UNITED STATES PATENT AND TRADEMARK OFFICE

Office Action Summary	Application No.	Applicant(s)	
	10/666,499	DEGABRIELE ET AL.	
	Examiner	Art Unit	
	Philip Gabler	3637

DETAILED ACTION

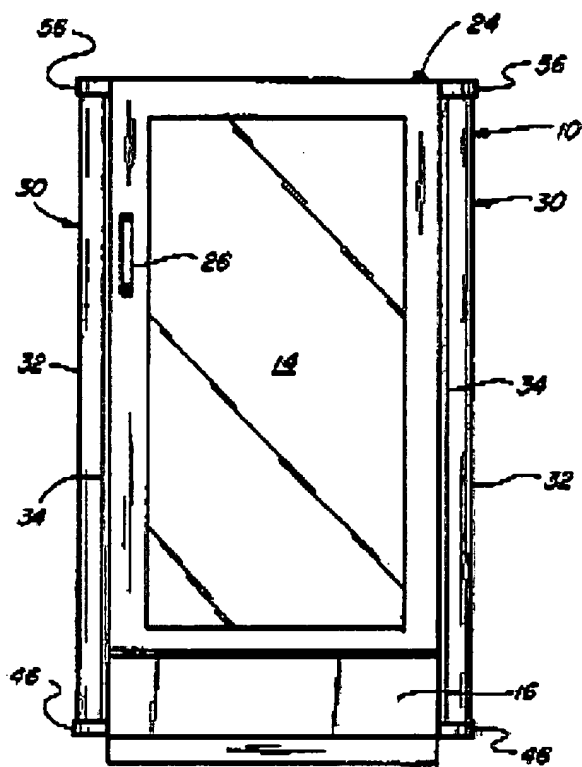
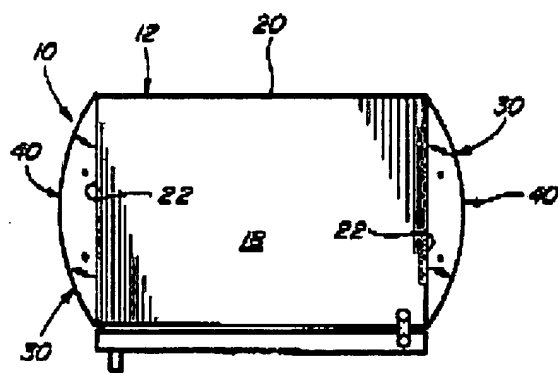
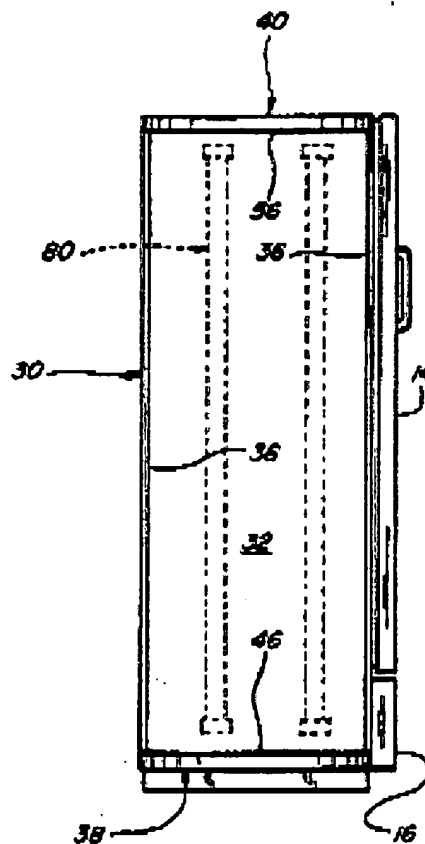
5. Claim 1 is rejected under 35 U.S.C. 102(b) as being anticipated by Trulaske (US Patent Number 5584547). Trulaske discloses a storage cabinet wherein: said cabinet includes first and second side walls (32), top and bottom walls (18) and (38), a vertically adjustable door (14), a door hinge (24) and a spacer panel (16); said side walls each includes a height, a length, a forward edge and a rear edge; said top and bottom walls each includes a length and a width; said top and bottom walls are attached to said side walls along a portion of the length of said side walls, the lengths of said top and bottom walls being less than the lengths of said side walls; said spacer panel is attachable to

said side walls adjacent to either said top wall or to said bottom wall as a function of which of said top wall and bottom wall is in the vertically lowest location; said door is attached to one of said side walls at a vertical position which location is function of the placement of said top and said bottom wall; and said door hinge is attached to said door and attachable to said one of said side walls.

Davidson '851 Figure 4

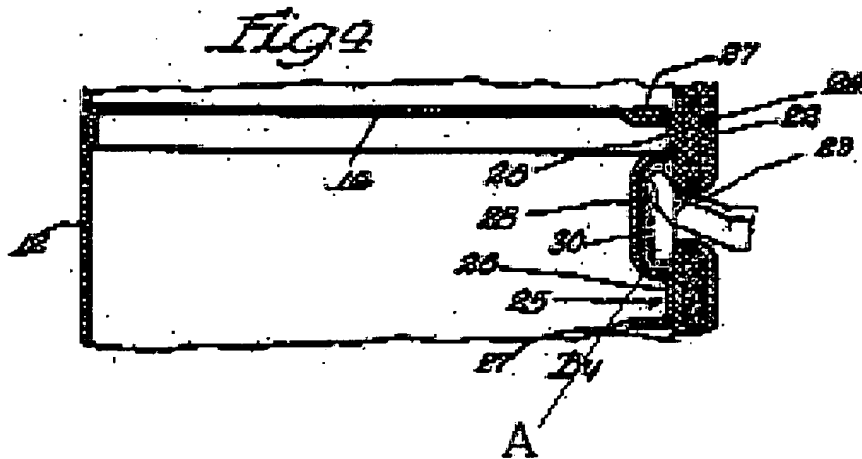
8. Claim 3 is rejected under 35 U.S.C. 103(a) as being unpatentable over Trulaske in view of Davidson (US Patent Number 2653851). Trulaske discloses a cabinet as recited in claim 1, but does not include a slanted edge on the forward edge of the side wall. Davidson discloses a cabinet with a slanted edge (A). It would have been obvious to one of ordinary skill in the art at the time the invention was made to modify Trulaske's cabinet to include a slanted edge on the forward edge of the side wall to facilitate the operation of a door as taught by Davidson.

Clegg '514 Figure 1

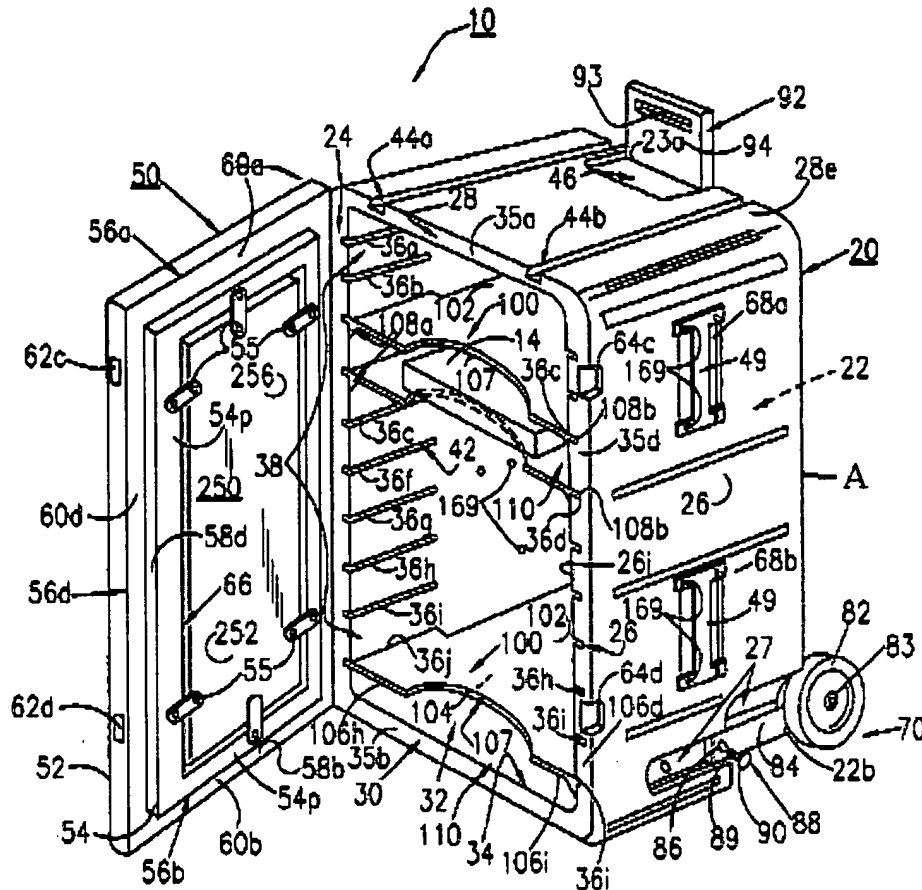
10. Claim 4 is rejected under 35 U.S.C. 103(a) as being unpatentable over Trulaske in view of Clegg (US Patent Number 6520514). Trulaske discloses a cabinet as recited in claim 1, but does not include a recess in the rear edge of the side wall not attached to the door. Clegg discloses a filing case (10) with a recess (27) formed in the rear edge (A) of its side wall (26) not attached to its door (50). It would have been obvious to one of ordinary skill in the art at the time the invention was made to modify Trulaske's cabinet to include a recess as taught by Clegg for wires, etc.

Gianelo '308 Figure 3

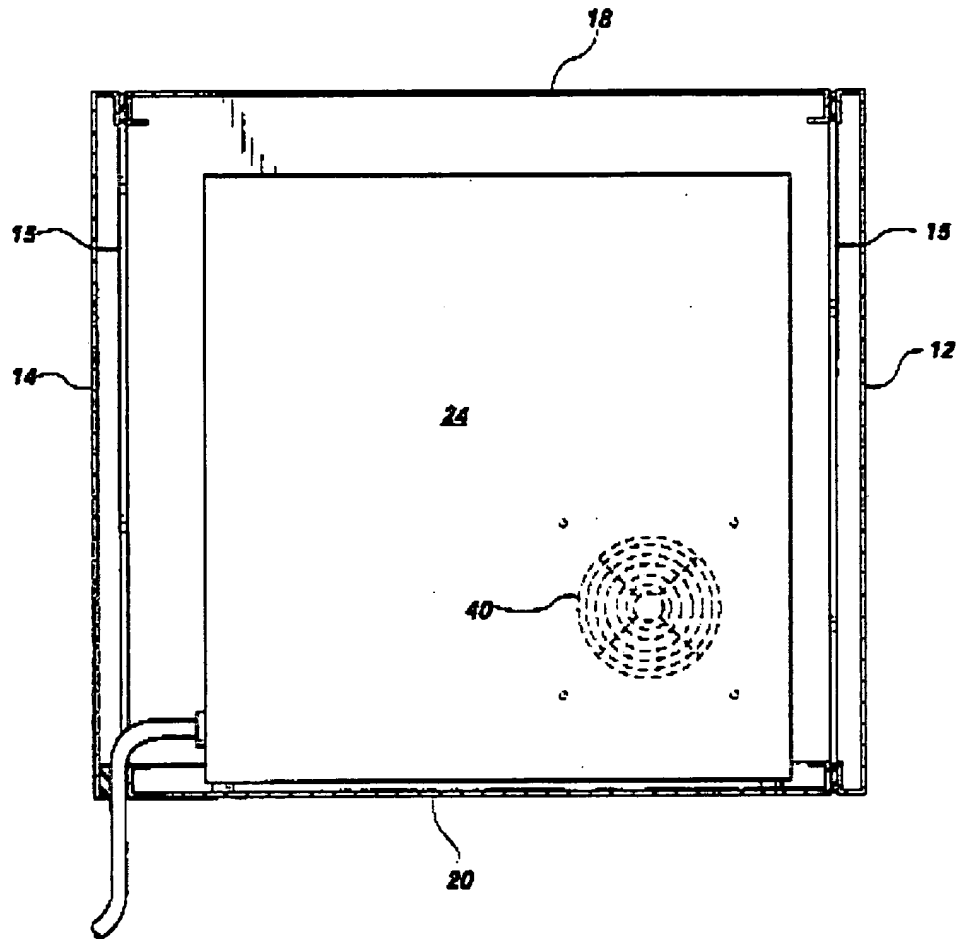
12. Claims 5 and 6 are rejected under 35 U.S.C. 103(a) as being unpatentable over Trulaske in view of Gianelo (US Patent Number 6589308). Trulaske discloses a cabinet as recited in claim 1, but does not include an air grille attached to the side wall or a back panel forming a rear opening. Gianelo discloses a computer cabinet including an air grille (40) attached to the side wall (24), and a back panel (12) forming a rear opening (15). It would have been obvious to one of ordinary skill in the art at the time the invention was made to modify Trulaske's cabinet to include an air grille and a rear opening as taught by Gianelo for ventilation of and access to the device stored in the cabinet.
